**MAJOR PROJECT ASSESSMENT:
RESIDENTIAL DEVELOPMENT CONCEPT
PLAN, SANDY BEACH NORTH
(MP 05_0083)**

Director-General's
Environmental Assessment Report
Section 75I of the
Environmental Planning and Assessment Act 1979

December 2010

Figure 3: Project Layout

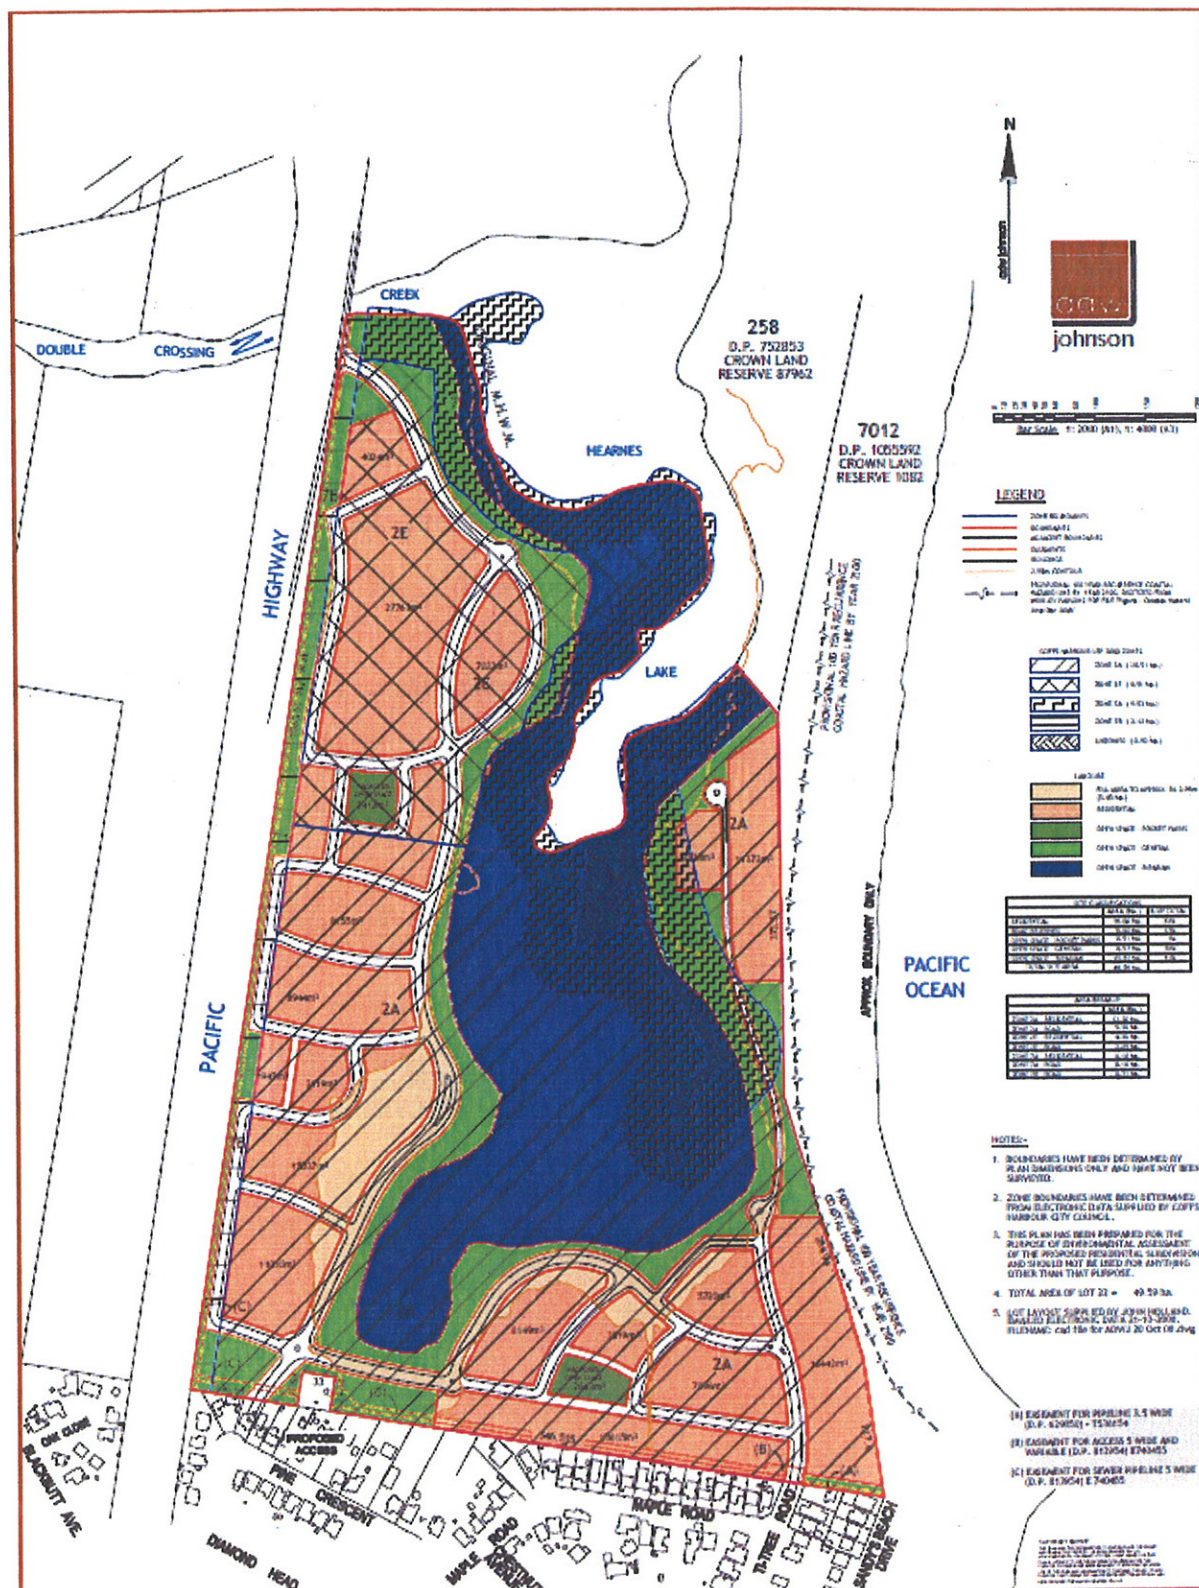
Firstly, the application includes a direct connection to the Pacific Highway at the northern end of the site, just south of Double Crossing Creek (refer to **Figure 3**). The proponent states that the RTA has granted approval to a "left in and left out" connection to the Highway along the western boundary of the site. This connection to the Highway is not supported by Council.

In their submission on the PPR, the RTA stated that despite their approval in principle "*very little detail has been provided at this time of its design nor has it been demonstrated that it will operate safely and efficiently*" and that until the RTA has been satisfied that this can be achieved "*it would be preferable to exclude this connection from the approval*". They go on to advise that this connection can be negotiated, if required in the future and will need the approval of Council with concurrence from the RTA. The Department recommends that direct connection to the Pacific Highway not form part of this approval.

Figure 8: Plan of Existing Vegetation Communities

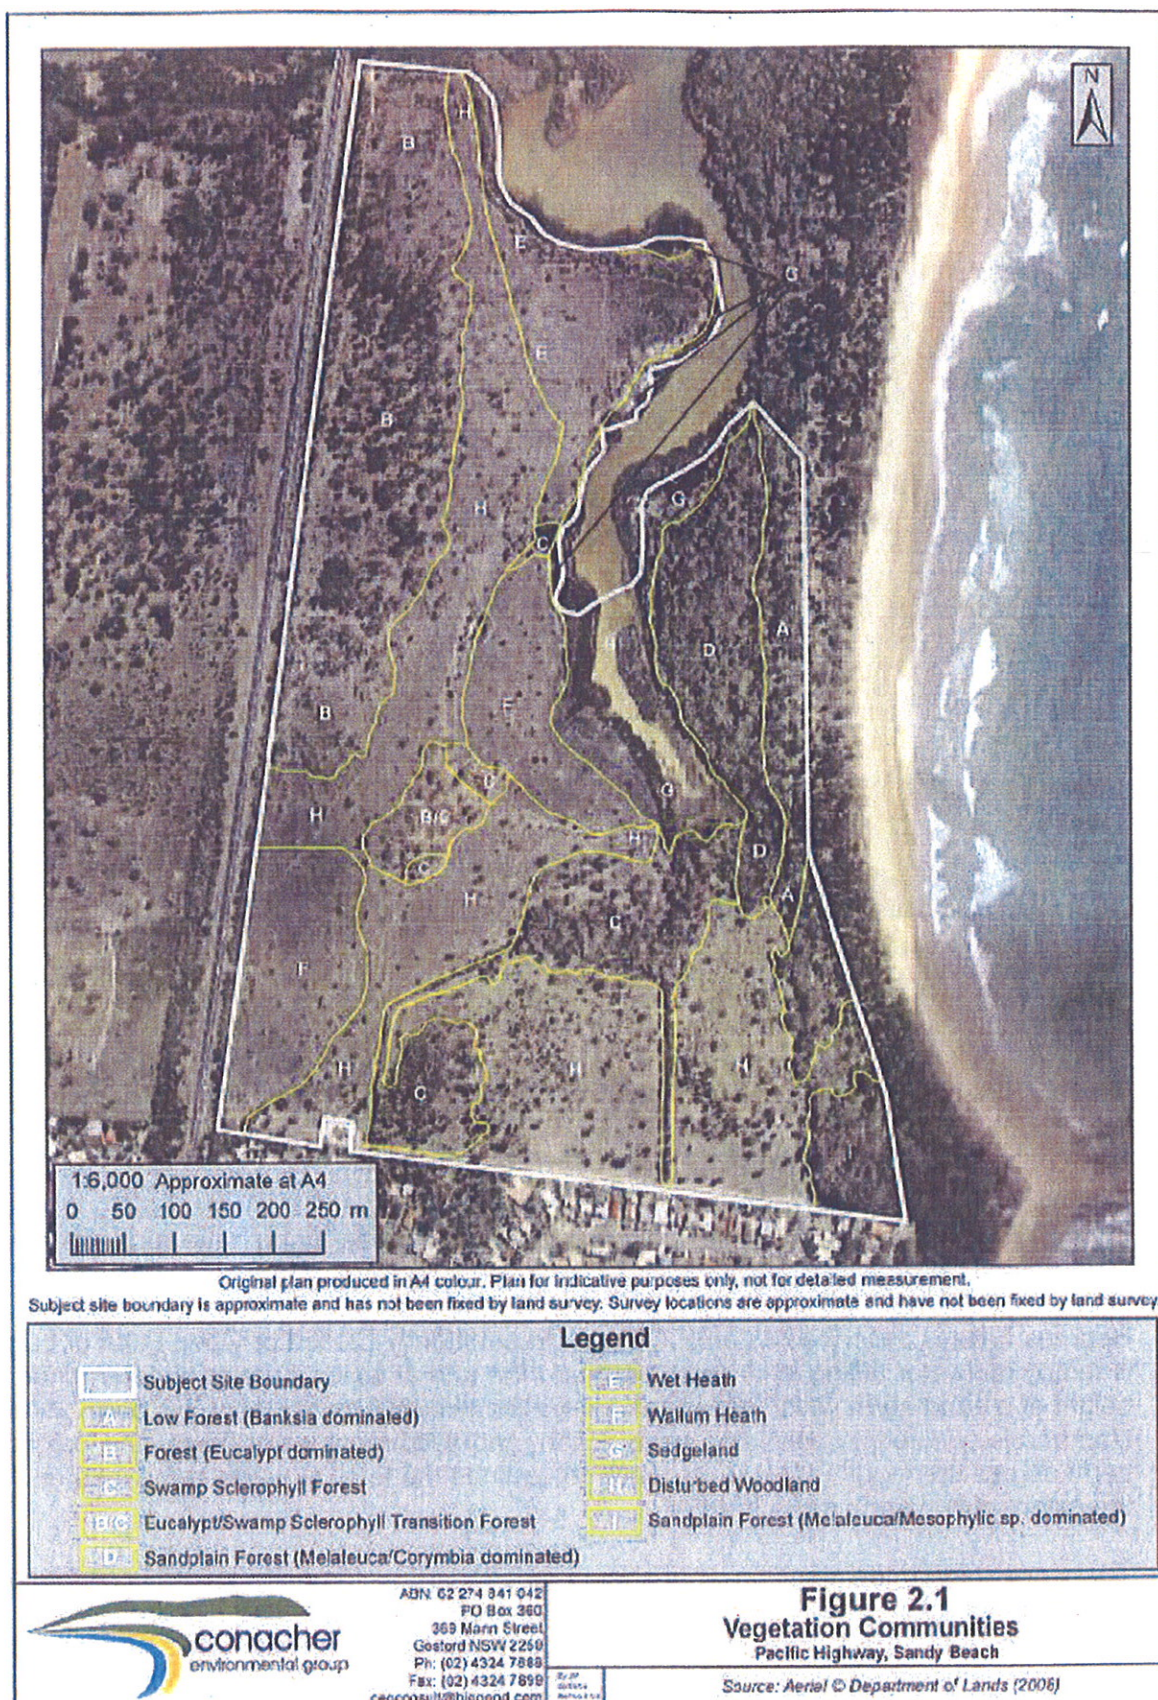
With reference to **Figure 8 'Plan of Existing Vegetation Communities'** on the site, the development of the subdivision as proposed would result in the:

- removal of virtually all of the vegetation communities:
 - 'B', which Sainty and Biolink regard as EEC;
 - 'B/C' which all parties agree is EEC, and
 - 'I', parts of which the proponent's ecologist has accepted is EEC.
- removal of substantial parts of 'F' and 'H', which although heavily degraded through slashing/grazing, still meet the description of EEC according to Biolink;
- and would impact on:
 - 'C' that exists within the south of the site, as a result of road and stormwater infrastructure construction, which all parties agree is EEC; and
 - 'A' and 'D' in the east of the site.

While the Department acknowledges the varying quality of the EECs on site, the extent of the loss is considered unacceptable. The Biolink review recommends retention of the vegetation communities to the east and south-east of Hearn's Lake and recommends that EEC areas on the rest of the site, outside buffers to the lake, may be developable, subject to an appropriate offset.

The Department has determined that it can accept limited development within areas of EEC and has largely accepted the recommendations of the Biolink review. The Department believes a satisfactory offset for the removal and impact on EEC vegetation communities requires:

- the exclusion of development from vegetation communities 'A', 'D' and 'I' to the east and southeast of Hearn's Lake and that part of vegetation communities 'B' and 'H' that fall within the Stage 6 area of the Staging Area Plan (see **Figure 9**), and
- that the future subdivision application for Stage 5 be accompanied by an assessment to determine an appropriate offset for the development of this stage and the proposed arrangements to secure the offset for conservation purposes in perpetuity.

Figure 9: Staging Plan showing the Department's recommended modifications

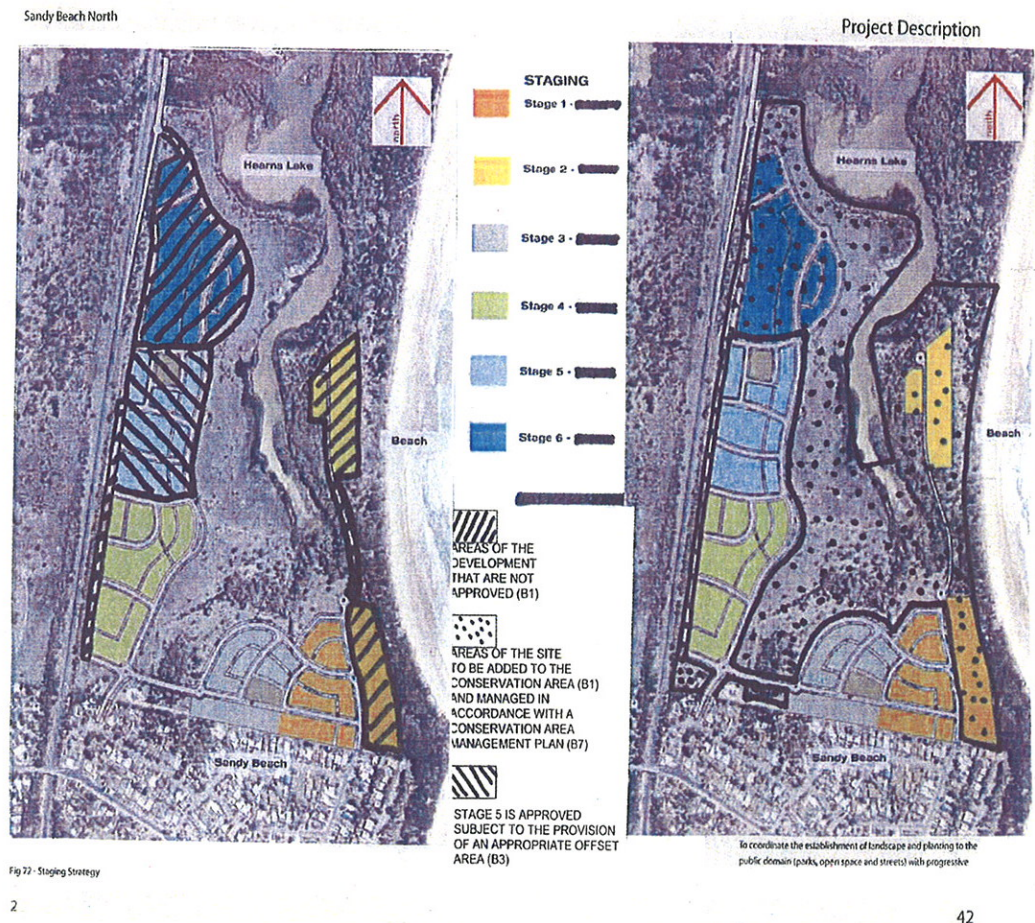
The areas excluded from development and to be added to a Conservation Area are shown on the marked up staging plan included at **Figure 9**.

This modification to the proposal, which would result in the loss of between 80 and 140 lots, would also have the following benefits:

In summary, the proposed development is considered to have an unacceptably high impact on vegetation communities of high conservation value, EECs and fauna habitat and is not supported in its current form. The Department recommend that certain parts of the site be excluded from development as depicted at **Figure 9**, and that the area identified as Stage 5

be the subject of further assessment to determine an appropriate offset area in order to an adequate offset for that area.

Figure 10: Extent of Roads with a finished Surface Level of RL3.6m AHD

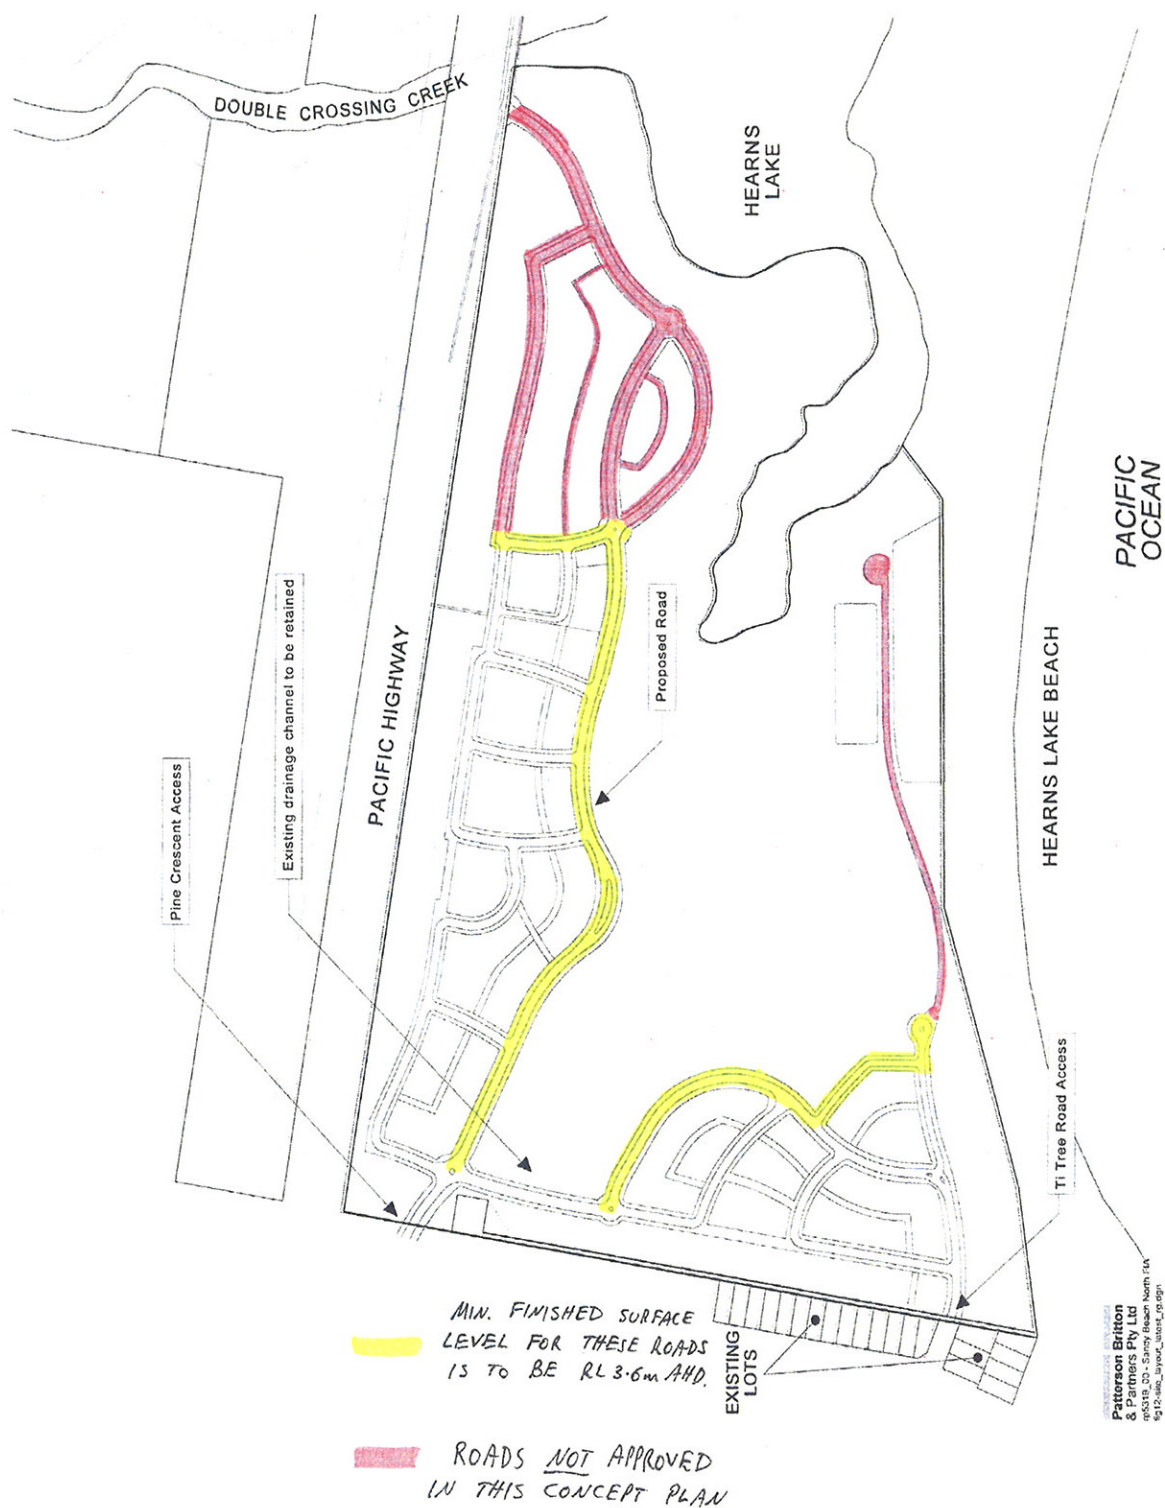
At a meeting on 22 October 2010, the proponent proposed that an approach be adopted where the roads on the lake side of the proposed subdivision be set to the Department's predicted flood level for the year 2100 (3.6m AHD), with the land behind these roads at a lower level (refer **Figure 10**). In this instance the roads would be acting as a buffer to the flood water. Some concern was expressed at how this approach would allow appropriate treatment and disposal of stormwater however the Department's consultant has advised that this solution is feasible, and that it would have a negligible effect on flood storage volumes.

The Department is satisfied that a berm height of 2.6m AHD is the appropriate height to adopt and that this means that the 2100 flood level would be 3.6m AHD including the lag effect. The Department recommends that a minimum road level of 3.6m AHD be set for the lakeside roads and a minimum floor level of 4.1m AHD be set for future dwellings in this subdivision. This is addressed in the recommend terms of approval.

Figure 11: Potential Aboriginal Archaeological Sites

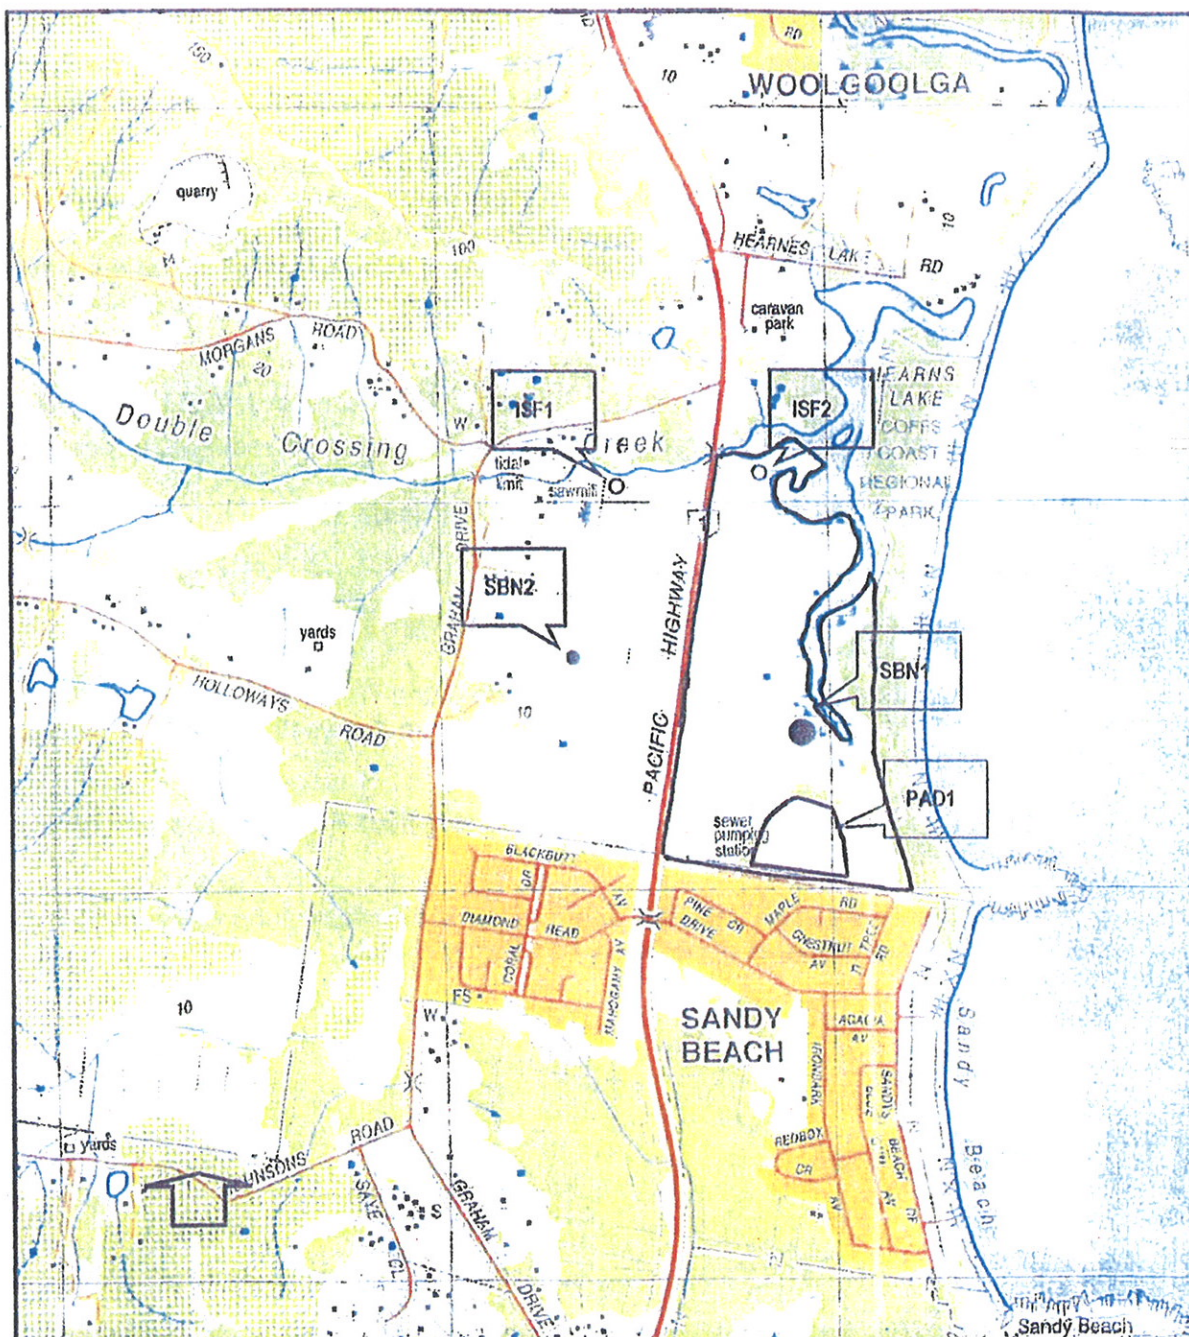
The Aboriginal Archaeological (AA) report submitted with the EA relates to both the subject site and land on the western side of the Pacific Highway. It identifies the subject site as possibly containing one isolated stone artefact (ISF 2), the disturbed remains of one open campsite (SBN 1), and one area of potential archaeological deposit (PAD 1). In terms of the current proposal, ISF 2 and SBN 1 are located outside the development footprint while PAD 1 is located directly over the main southern precinct. Their location is shown on the marked up site plan sourced from the submitted AA report (refer **Figure 11**).

In their response to the EA, DECCW advised that further investigation was required into the nature, scale, extent and significance of PAD 1, that any investigation be undertaken in consultation with registered Aboriginal stakeholders, and that evidence of this consultation be provided to the Department prior to the determination of any consent.

Although the Department would have preferred this issue to be resolved prior to Concept Plan determination no objection is raised to postponing these further investigations subject to them being undertaken as part of any further applications for this site.
